# Access Compliance Report

## Public Rights-of-Way

### (Curb Ramps)

Intersection ID: 53964	Main Street: SPRING_SPRUCE_LN	Cross Street: MAGNOLIA_LILY_AV	Location: NE
ADA ID: 08F18A7D78BE	Ramp Type: Perp	Initial Pass/Fail: Fail	Overall Compliance: No
Severity Score: 22.5			
Codes/Mitigation Info/Possible Solution		Field Measurements/Component Compliance

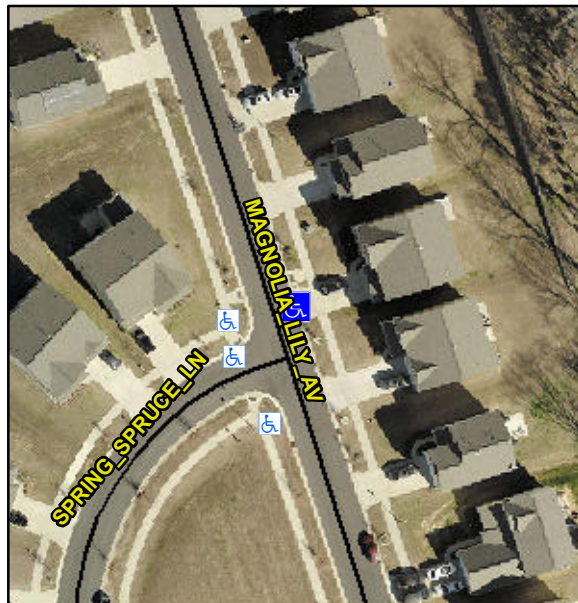
**Not Found, R304.5.1, R304.2.2, R304.5.3**

Compliance	Description	Data	Compliance	Description	Data
N/A	Ramp Length (in)	94.5	No	Ramp Slope (%)	8.4
No	Ramp Width (in)	47.0	No	Ramp XSlope (%)	4.1
N/A	Flare Type LT	N/A	N/A	Flare Type RT	N/A
N/A	Flare Slope LT (%)	N/A	N/A	Flare Slope RT (%)	N/A
N/A	Flare Traversable LT?	N/A	N/A	Flare Traversable RT?	N/A
N/A	Landing Length (in)	N/A	N/A	DWS Provided?	N/A
N/A	Landing Width (in)	N/A	N/A	DWS Contrast?	N/A
N/A	Landing Slope (%)	N/A	N/A	DWS Length (in)	N/A
N/A	Landing X Slope (%)	N/A	N/A	DWS Full Width?	N/A
N/A	Landing Curb? (Y/N)	N/A	N/A	DWS Offset (in)	N/A
N/A	Shared Landing?	N/A			
N/A	Gutter Ponding?	N/A	N/A	Gutter Slope (%)	N/A
N/A	Gutter Lip Ht (in)	1.0	N/A	Gutter X Slope (%)	N/A
N/A	Painted X Walk1?	No	N/A	Painted X Walk2?	N/A
	X Walk 1 Direction	To W		X Walk 2 Direction	N/A
N/A	X Walk 1 Width (in)	N/A	N/A	X Walk 2 Width (in)	N/A
	X Walk 1 Slope (%)	3.5		X Walk 2 Slope (%)	N/A
	X Walk 1 X Slope (%)	3.9		X Walk 2 X Slope (%)	N/A

**Remove & Replace Entire Ramp.**
